## Audio Noise in Systems mixing older 8-port Cards with TRIBUS / MADI / AIO-16s

# RTS™ TECHNICAL BULLETIN

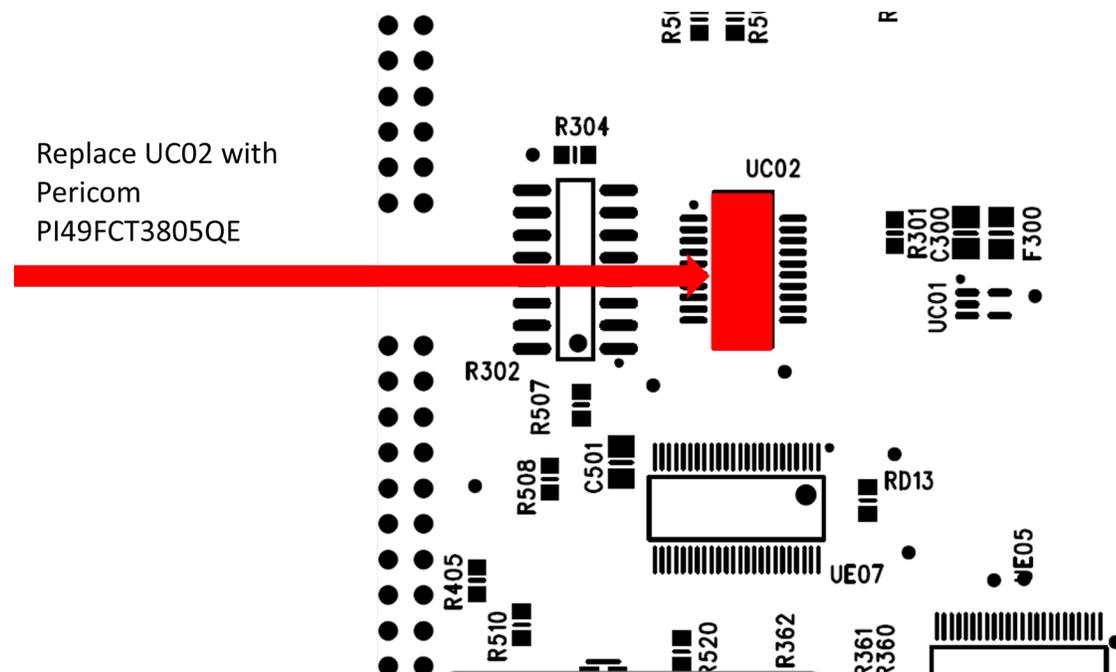
In order to fix this problem, the clock drivers on the TRIBUS, MADI and AIO-16 must be replaced with a footprint compatible device capable of driving a 5 V compliant output. The TRIBUS and MADI cards currently use the same Front Card PCB layout, so both of these cards can be fixed by replacing UC02. For the AIO-16, UH01 needs to be replaced.

## 3.0 TRIBUS / MADI Clock Generator IC Rework

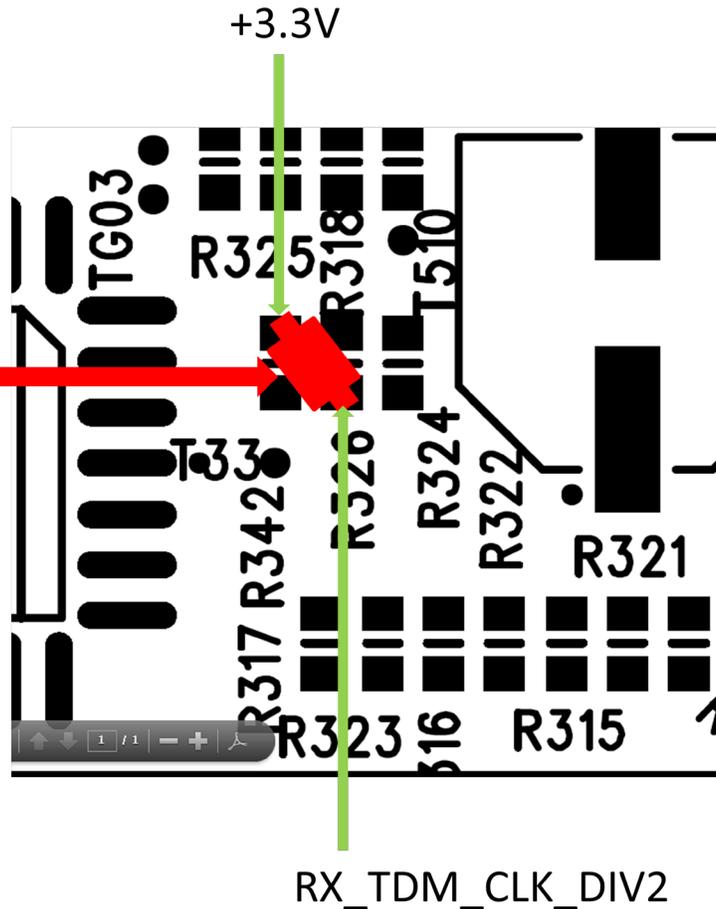
STEP 1: Remove UC02. Clean pads and install Pericom PI49FCT3805QE device.

STEP 2: Solder diode across following parts to clamp incoming clock reference signal to +3.3 Vdc rail:

Infineon  
BAT1503WE6327  
Schottky  
Clamp  
Diode  
SOD-323

Carefully place  
diode across R326  
and R342. Solder into  
position.

Cathode connects to  
+3.3V, anode connects  
to RX\_TDM\_CLK\_DIV2

## 4.0 AIO-16 Clock Generator IC Rework

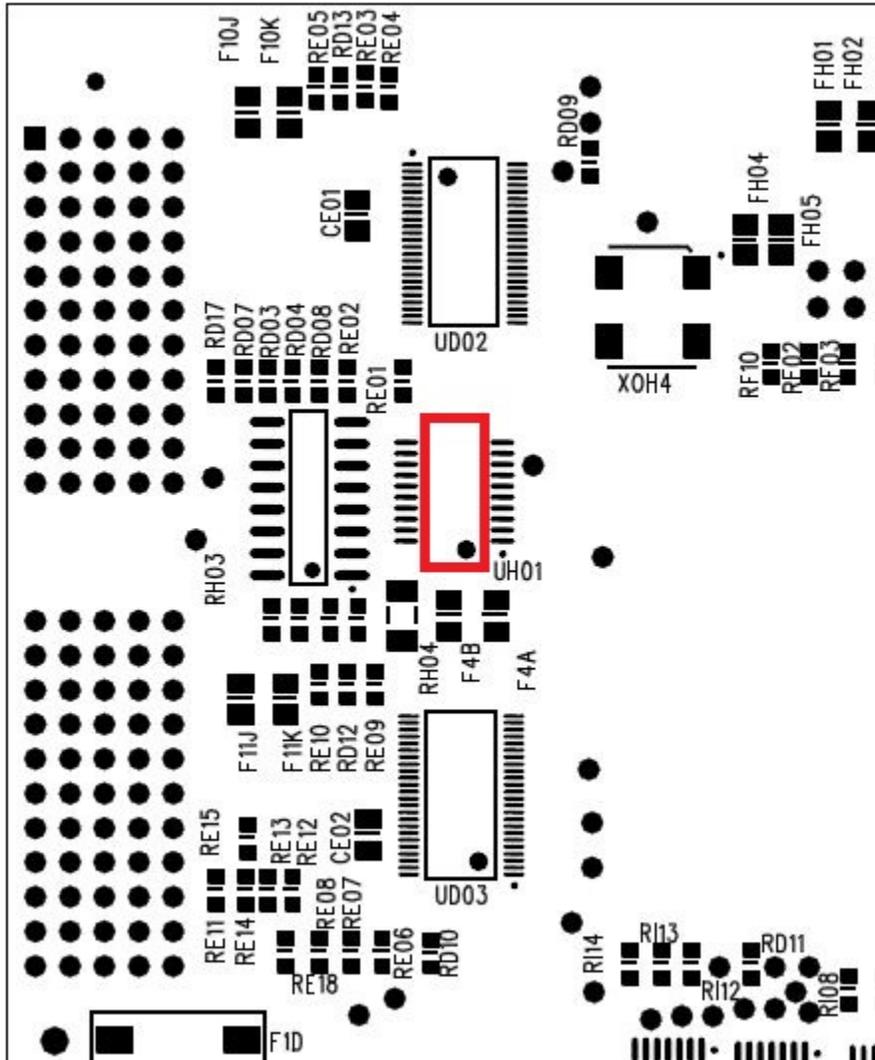
STEP 1: Remove UH01.

STEP 2: Clean pads and install Pericom PI49FCT3805QE device at location shown in photo below.
